CALIFORNIA COASTAL COMMISSION

APPEAL STAFF REPORT COURT REMAND DE NOVO HEARING

Appeal numberA-3-SNC-98-114, Monterey Bay Shores Ecoresort

Applicant.....Security National Guaranty Inc. (SNG)

Figure 1. Pacific Institute Sea Level Rise Hazards

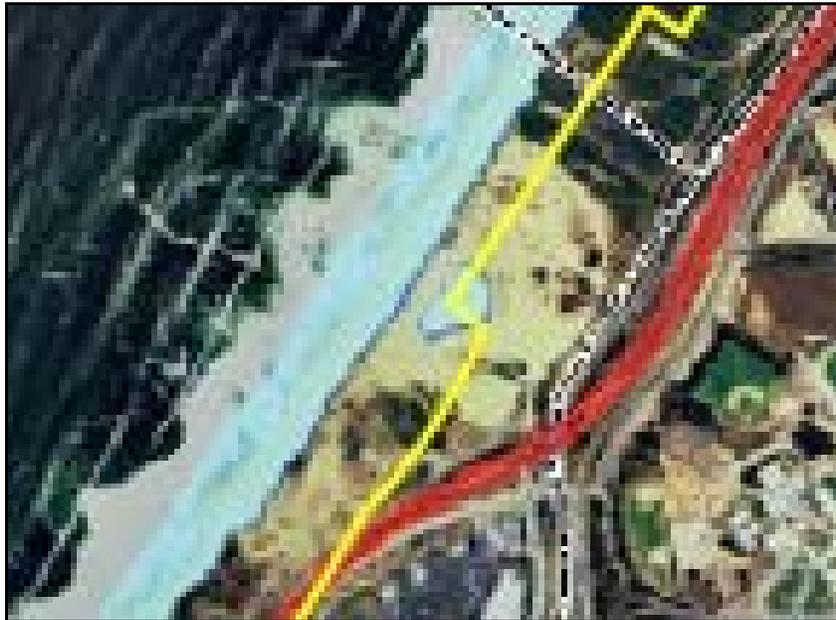
In March 2009 the Pacific Institute released a report evaluating the impacts of future sea level rise on the California coast. Using sea-level rise forecasts developed for the California Climate Action Team by researchers at Scripps Institution of Oceanography of 1.0 and 1.4 meters by 2100 (for low- and moderate-greenhouse-gas-emissions scenarios, respectively), it evaluated the effects of sea level rise on the area inundated by a 100-year storm event and on increased dune and bluff erosion rates. A key product was a set of hazard maps showing the area inundated by the 100-year storm event today and in the year 2100, and the zone at high risk from coastal erosion by the year 2100.

The analysis shows that a large part of the site would be subject to erosion, with the 2100 critical erosion zone ranging from 250 to 500' from the current bluff face (see Figure 1). Inundation hazards are identified along the dune face and in the depression (borrow pit) in the southern portion of the site. The analysis in the Pacific Institute study did not examine the inundation risks for either the proposed lowering of the frontal dunes or for the combined impact of erosion and flooding. In general, however, the Pacific Institute analysis identifies hazard conditions similar to those analyzed by Commission staff and confirms that the added impact of sea level rise to the erosion and inundation hazards could significantly increase site hazards in the future.⁶⁶
